# Historical Architectural Review Board COA Final Review Sheet

HDC-2023-00063

Address: 619 N. Park Street

Proposal: Legalize installation of porch header, posts, and railings

Front façade of 619 N. Park Street, 2018. (Google StreetView)

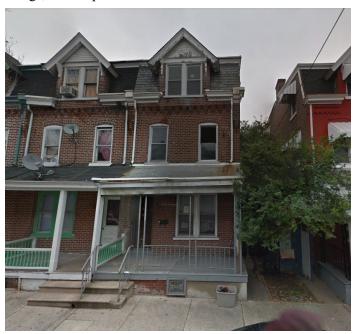
The applicant purchased the property in June 2023 and contends that the work was done prior to the sale. The historic wood porch had been altered at some point in the past and metal posts and railings were installed, and the porch floor was changed from wood to concrete. The current alteration removed the inappropriate metal railings and posts. Three of the metal posts were replaced with wood, and one metal post remains. The railings were replaced with wood pickets. While the work does not replicate the historic appearance of the porch, the guidelines recommend but do not require a full

restoration to the porch's original appearance. Guideline 3.7.6 states that applicants should "consider restoration of previously altered porches with historically appropriate elements." Staff finds the installation of wood to be more appropriate than metal but contends that the materials do not reflect the architectural style of the building. The guidelines advise against altering the architectural style of the porch (p. 67). Staff suggests installing turned wood columns and balusters, and installing post brackets that approximate the porch's historic appearance and better relate to the style of the original porches in the row.

The carpet does not comply with Guideline 3.7.8 and should be removed.

Mr. Lichtenwalner moved to approve with conditions the application presented on 10/2/2023 to legalize the installation of the porch header, posts, and railings, pursuant to Chapter 3, Section 3.7 Porches & Steps, provided the following:

- The corner metal porch post is replaced with a solid wood post;
- The existing spindles are reused and inserted into the top and bottom rails;
- The top rail is of an appropriate size and form to fit the spindles as presented in the application;
- All wood elements are painted; and
- The carpeting is removed to expose the concrete porch floor.
